Merged Synchronization State Machine

IEEE 802.3bp - Interim Meeting - May 2015

William Lo, Marvell

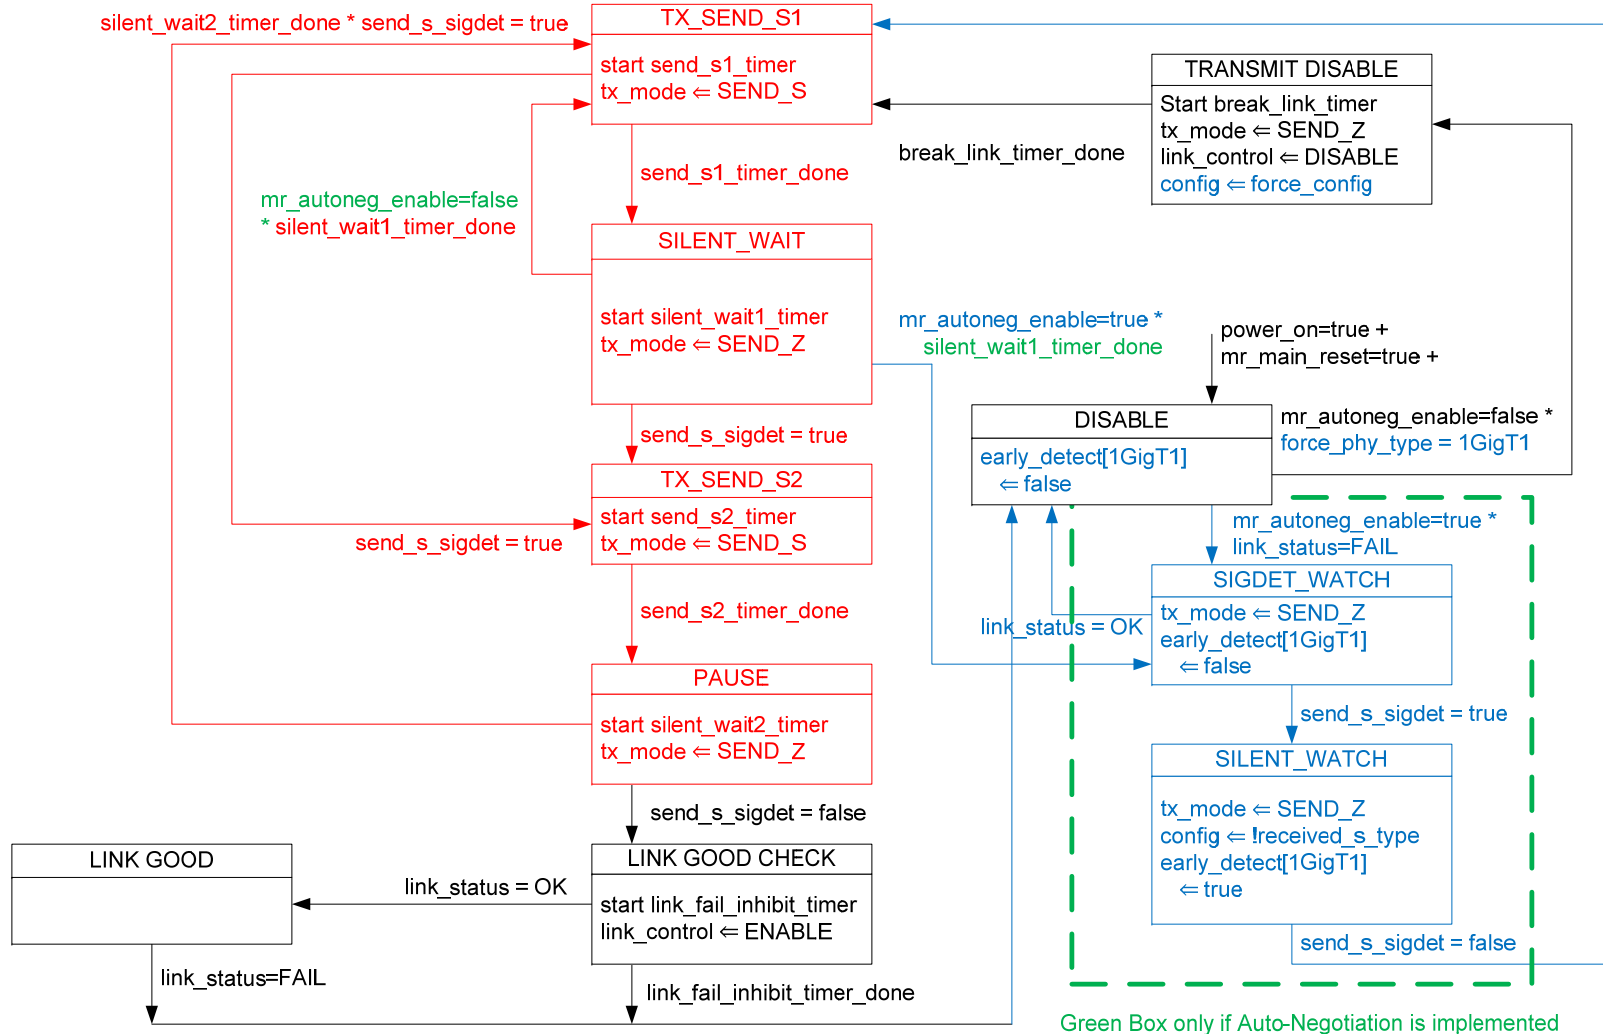
- ▶ **Merges tu_3bp_03_0215.pdf page 8 and lo_3bp_01_0315.pdf page 5.**

- ▶ Red – tu_3bp_03_0215.pdf, Blue – Lo_3bp_02_0315.pdf, Green - New

Auto-Negotiation Arbitration State Machine

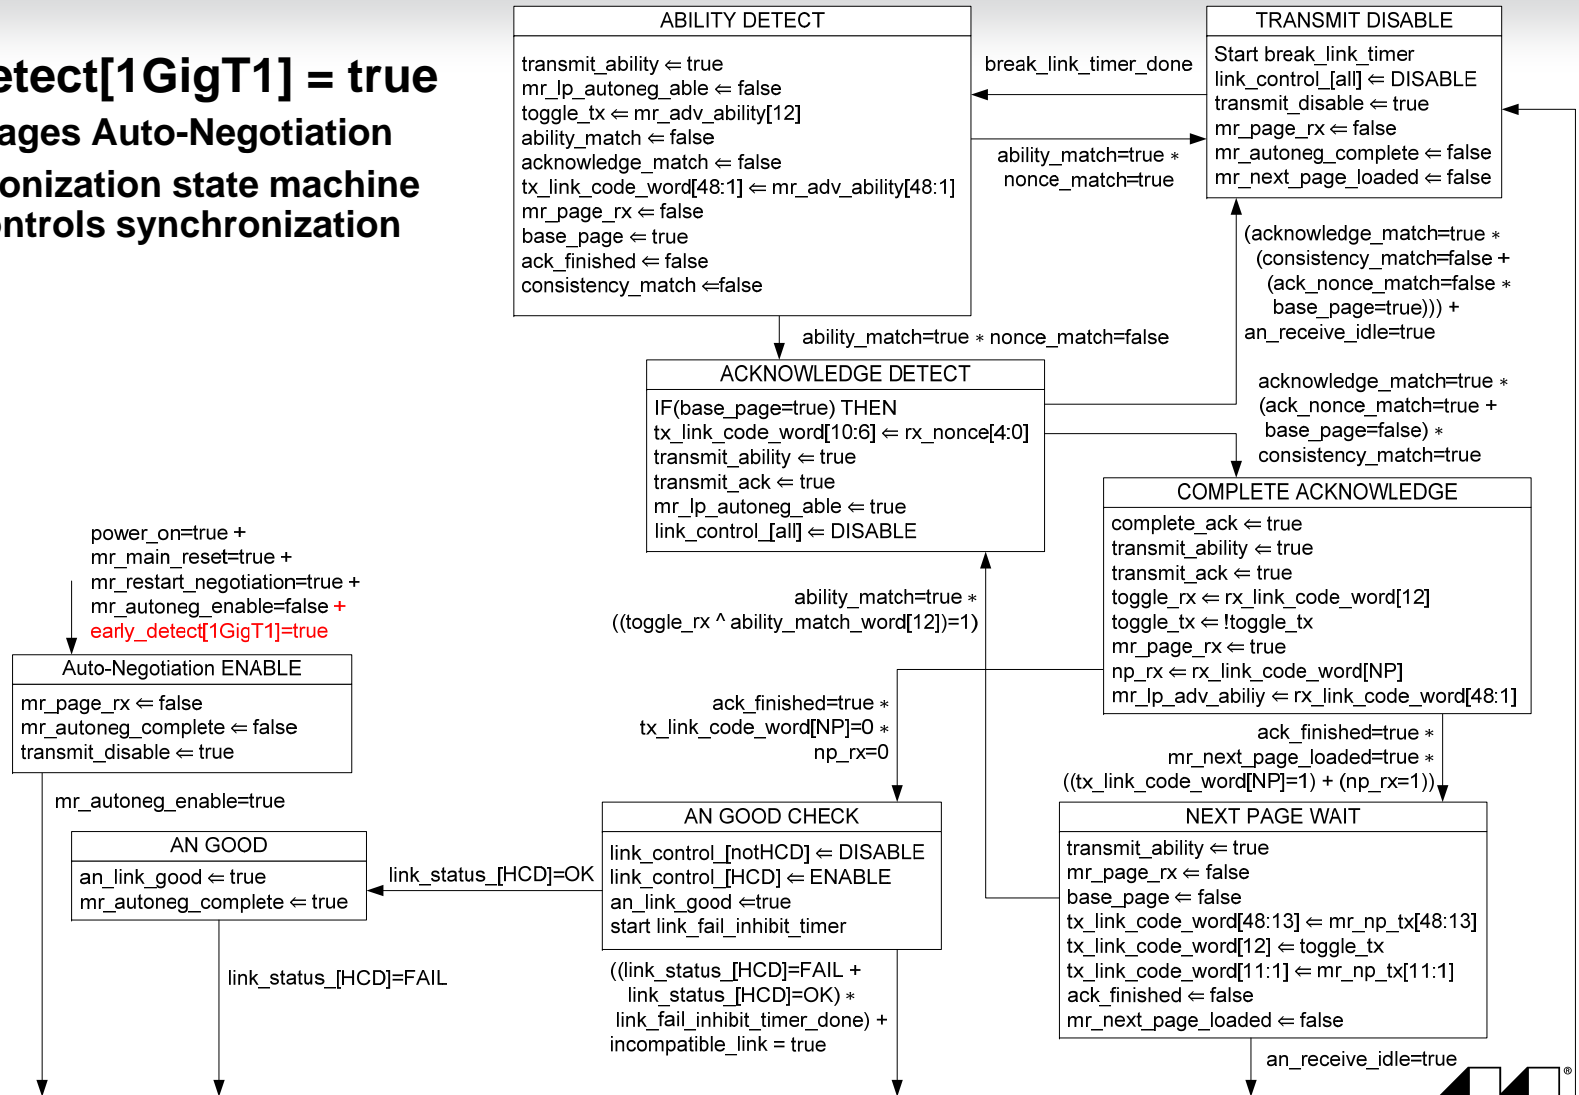
▶ **early_detect[1GigT1] = true**

- Disengages Auto-Negotiation
- Synchronization state machine fully controls synchronization
